NATIONAL TRANSPORTATION SAFETY BOARD

MATERIALS LABORATORY ERRATA / ADDENDUM REPORT

Report No. 00-148

Place : Nantucket, Massachusetts
Date : October 31, 1999
Vehicle : Boeing 767-366ER
NTSB No. : ~~DCA00M-A006~~ DCA00MA006 GP
Investigator : Scott Warren, AS-40

Figure 29A. SEM view of the fracture in the rivet located opposite to the rivet denoted by arrow "rv" in figure 28. The arrow indicates the step. (26.7X).

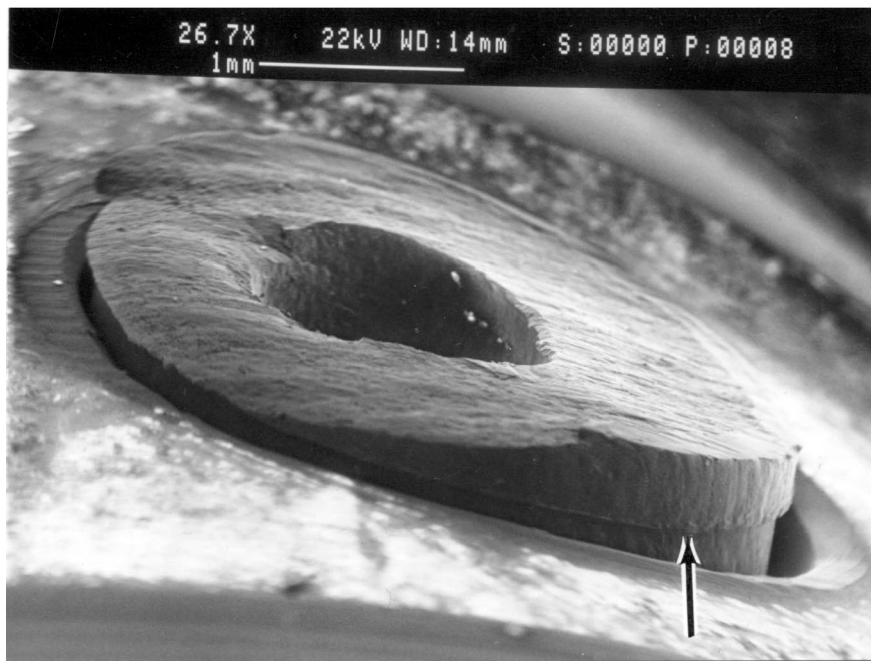
1. The following text replaces the text in the last two paragraphs on page 8 and the top of page 9 of Materials Laboratory Report No. 00-071. Also note that a new figure (29A) has been added and is attached to this report.

The shank of the other rivet from the No. 5 bellcrank's green arm (opposite from rivet "rv") contained a step at a similar location, flush with the bottom of the recess. Figure 29A shows an SEM view of this rivet fracture, with the step indicated by the arrow. The direction of the deformation associated with this step was as if the rivet was subjected to a shear load opposite to the direction of the shear load associated with the rivet fracture. None of the rivets from the No. 3 and No. 4 bellcranks contained evidence of similar damage. The circumferential damage (crack, mark or step) on the rivets from the No. 5 bellcrank appeared to follow the contour of the corner between the recessed portion of the bearing surface and the rivet hole.¹
